GRADING & EROSION CONTROL PLAN

EL LICOTT SCHOOL ADDITION - 2 BUILDINGS

GRADING & EROSION CONTROL PLAN COVER SHEET

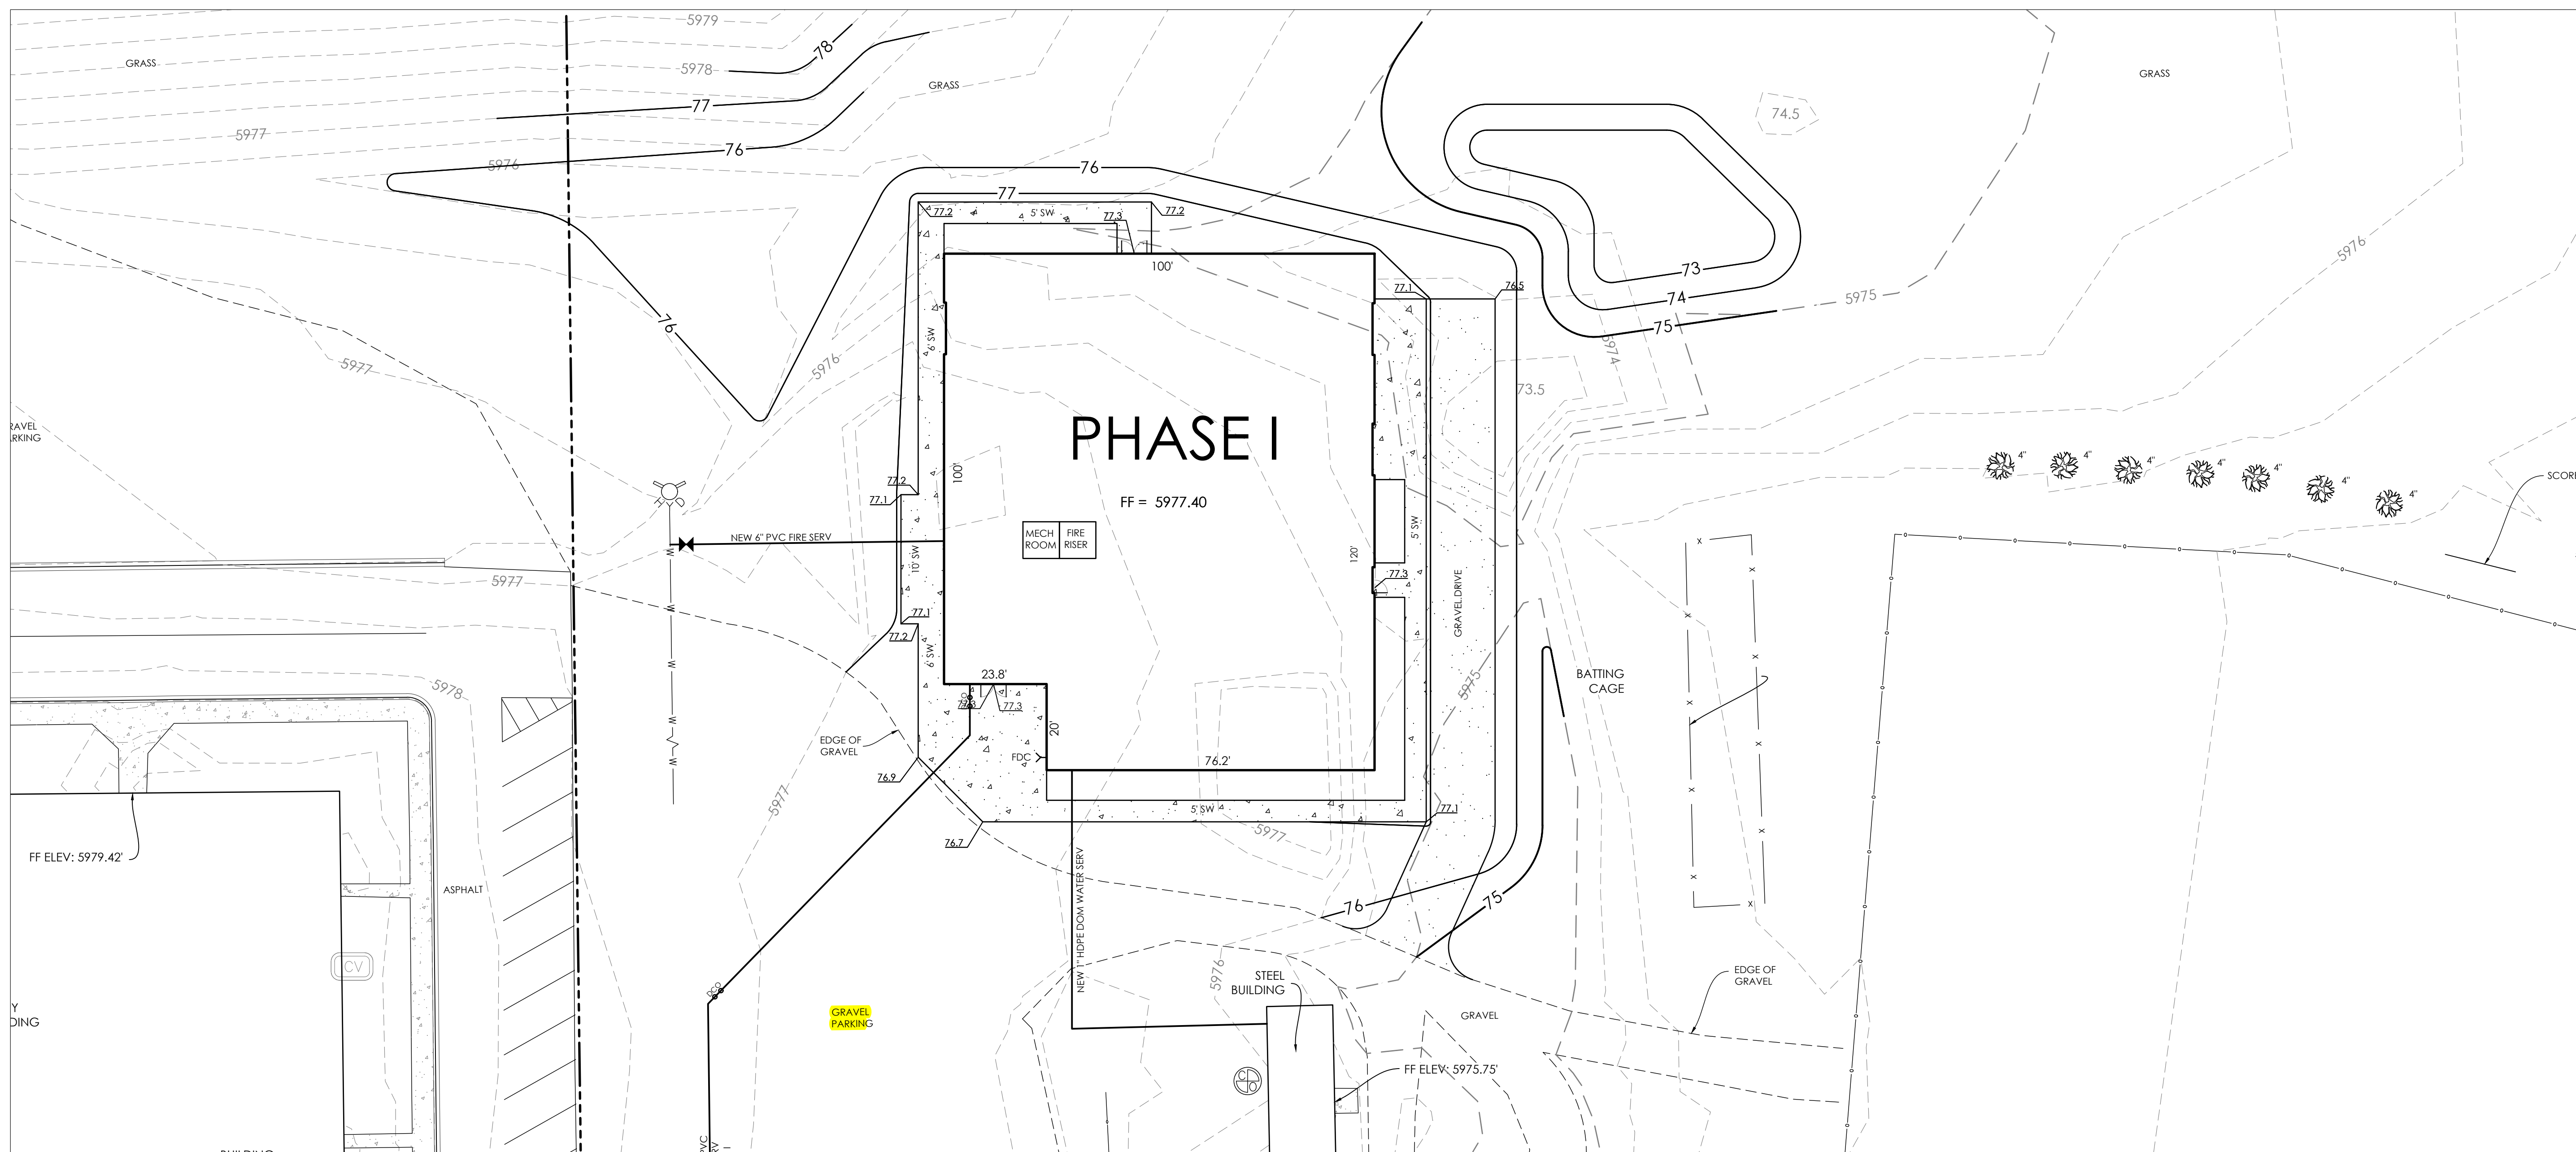
Show gravel areas in legend on on GEC plan drawing all sheets

Add PCD File PPR-22-050

Include note 28 as shown in GEC Checklist. If N/A, input "N/A" into blank shown in that note.

PHASE I
GRADING PLAN

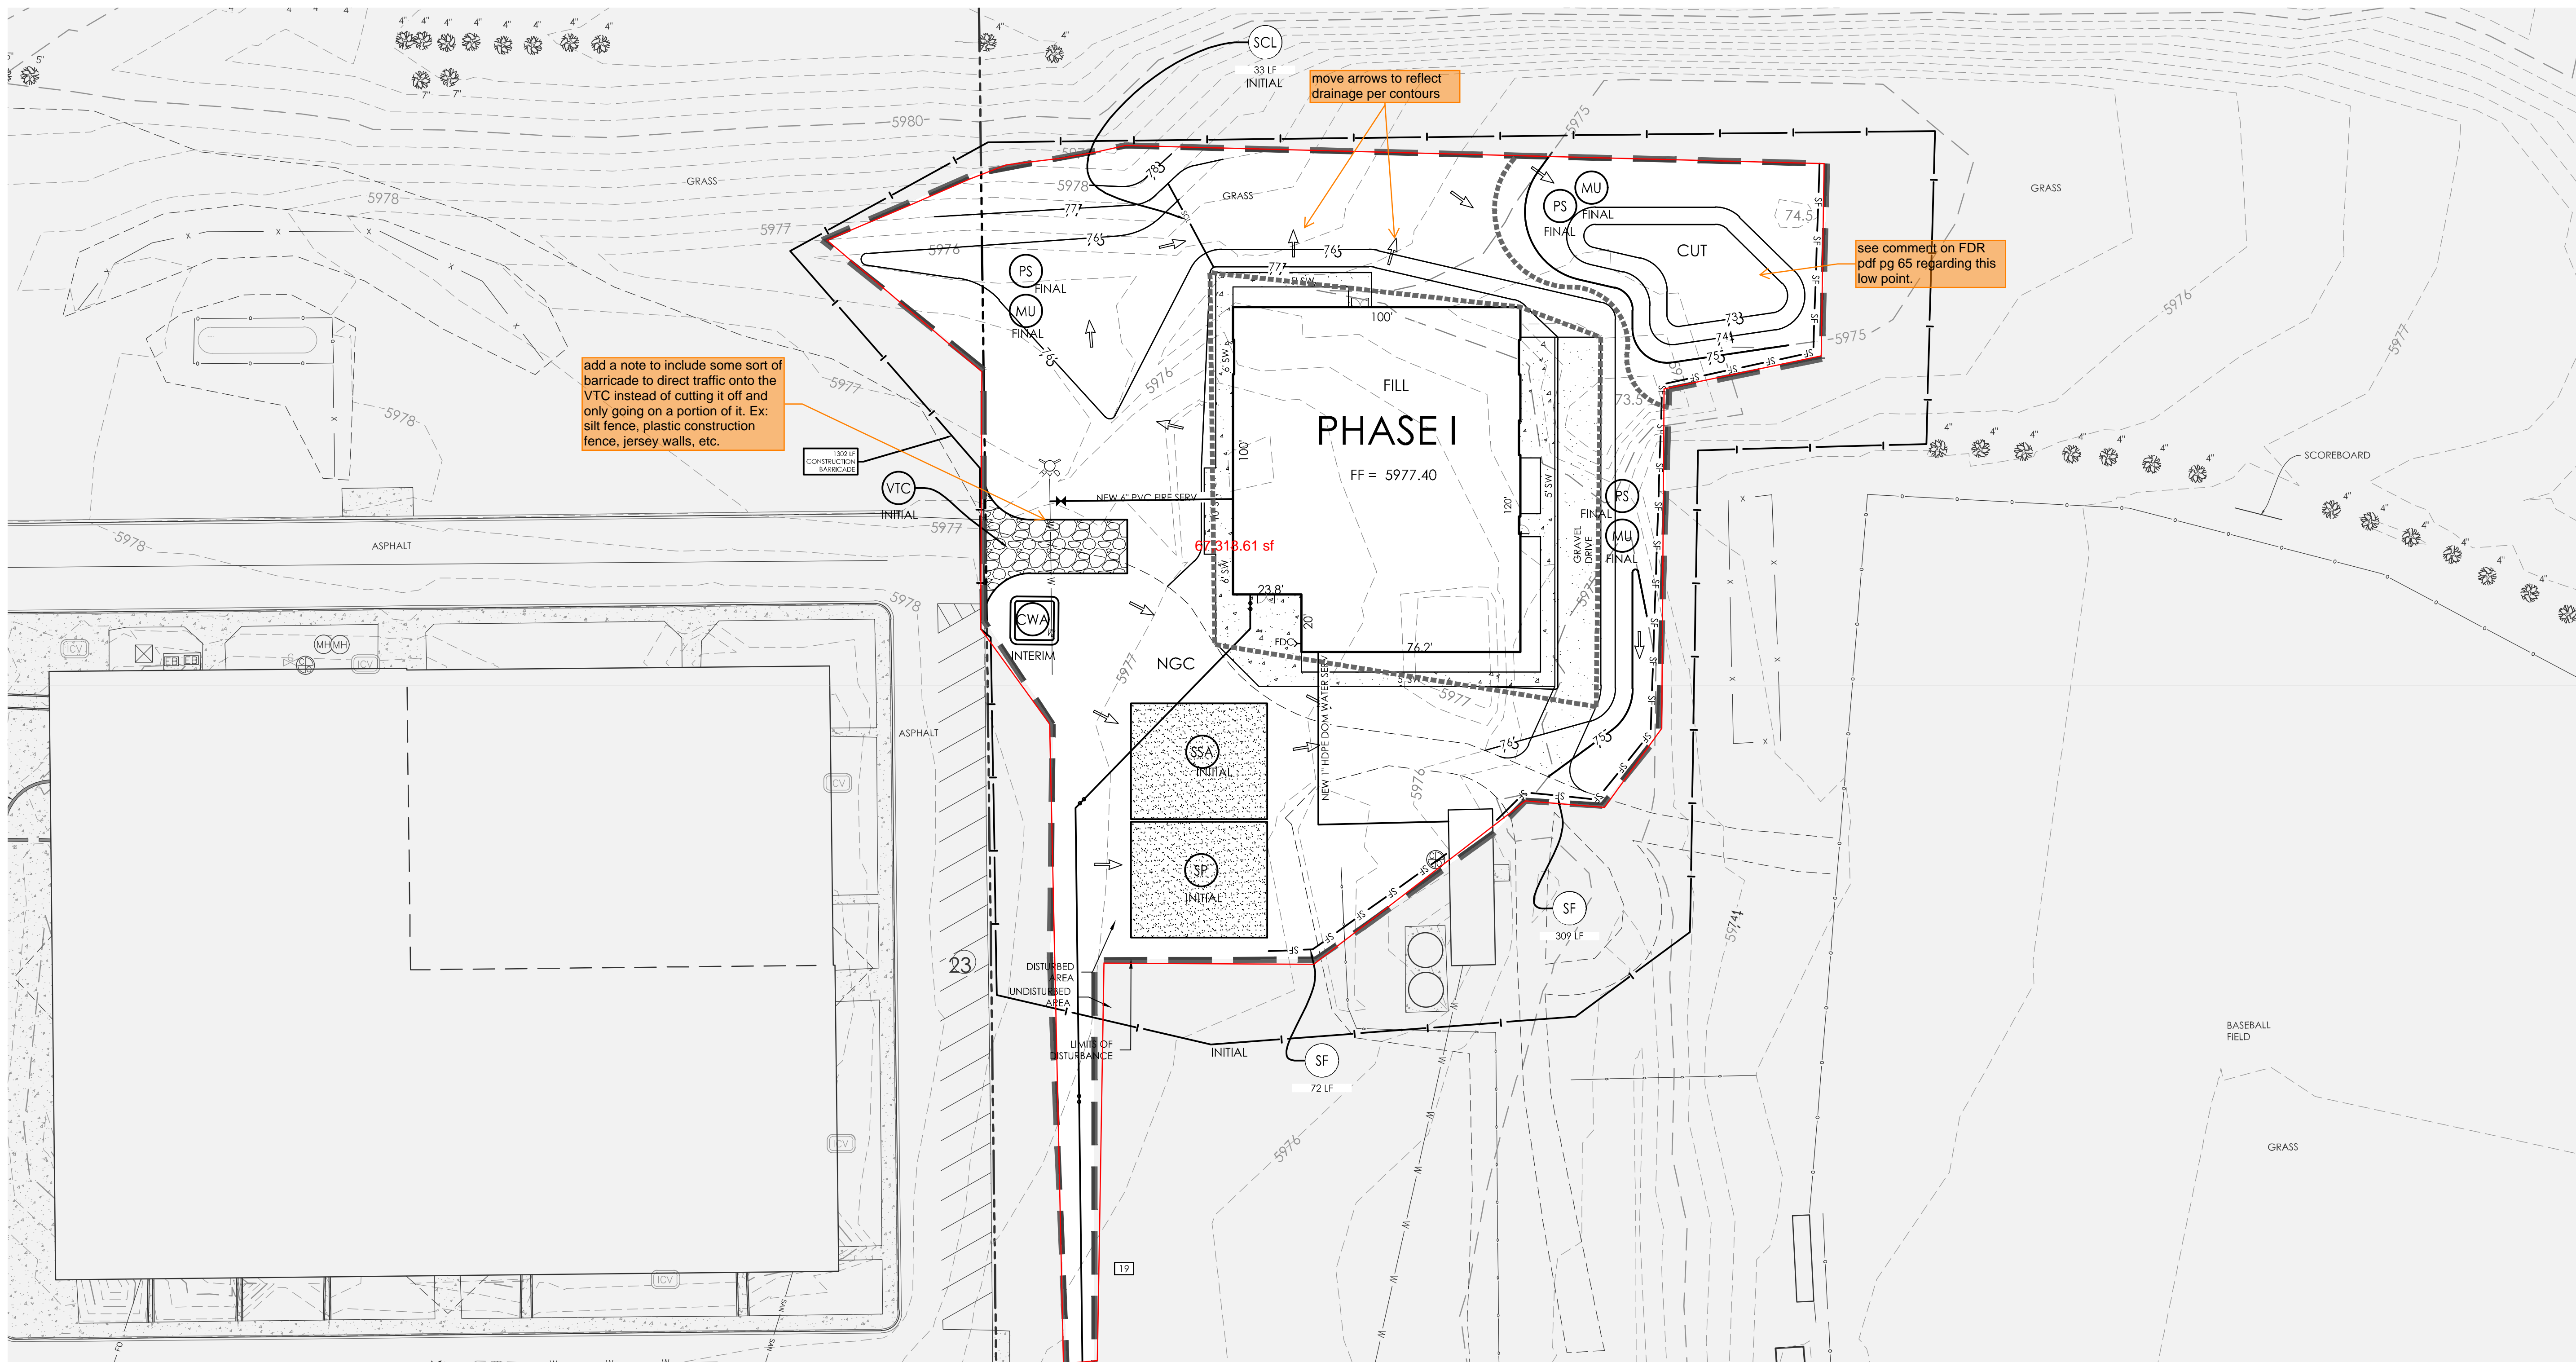
add a note to include some sort of barricade to direct traffic onto the VTC instead of cutting it off and only going on a portion of it. Ex: silt fence, plastic construction fence, jersey walls, etc.

move arrows to reflect drainage per contours

see comment on FDR pdf pg 65 regarding this low point.

PHASE I EROSION CONTROL PLAN

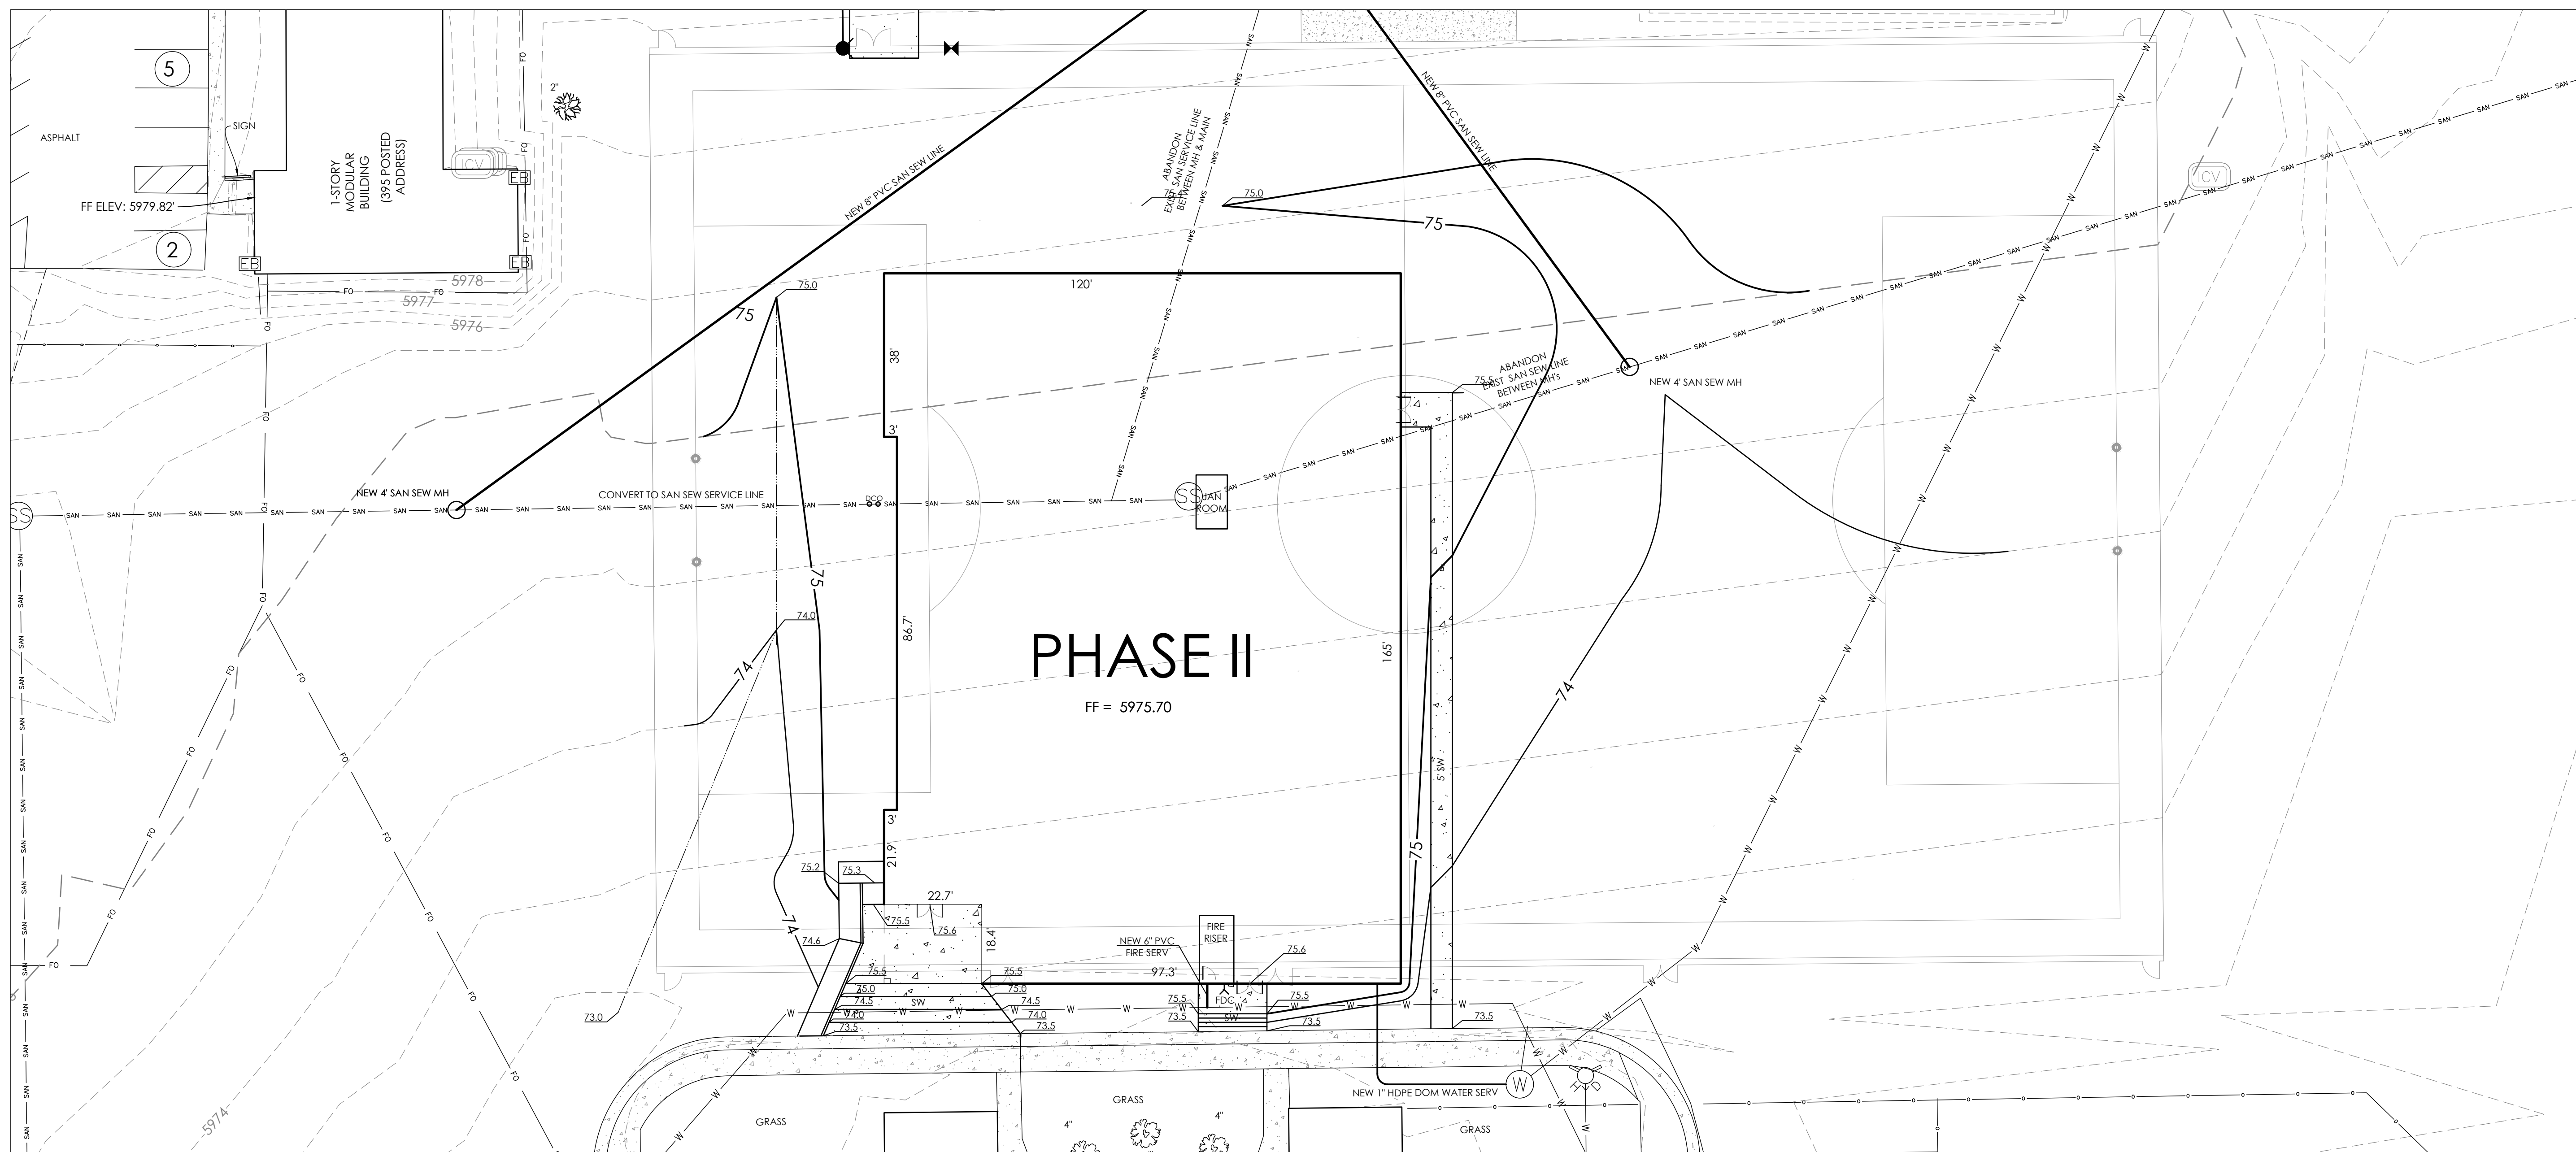
Call out Temp Sediment Basin and add to plan
